STANDARDS AUSTRALIA

Amendment No. 2
to
AS 2741—2002
Shackles

SUMMARY: This Amendment applies to Clauses 2, 5.2.5 and 9.2.3, Figure 1 and Appendix D.

FIGURE 1 TYPICAL POSITIONS FOR MARKING SHACKLES

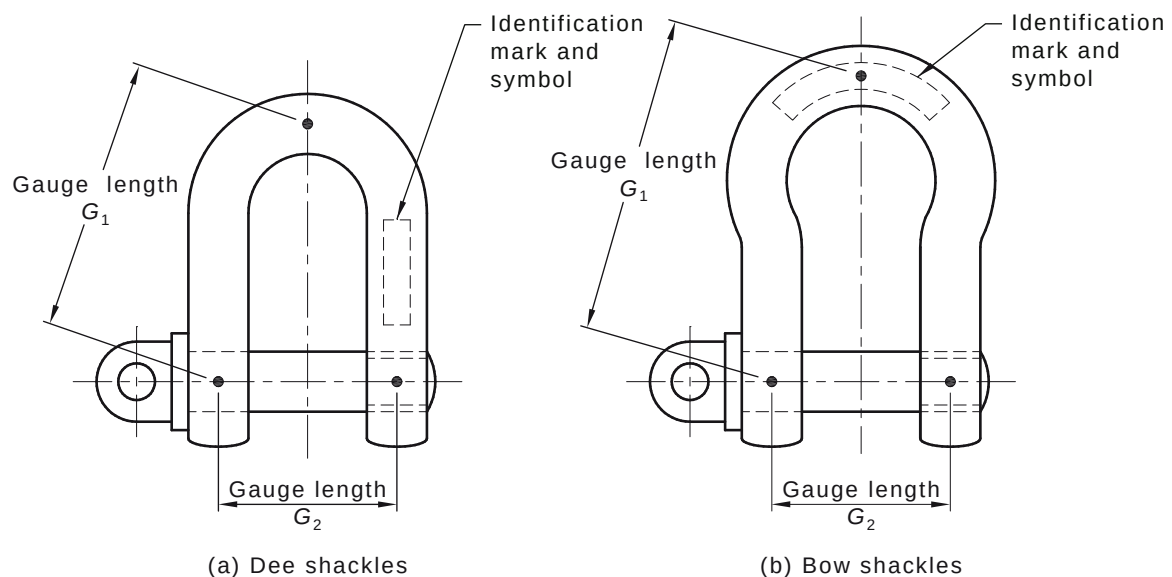
Delete existing Figure 1 and *replace* with the following new Figure:
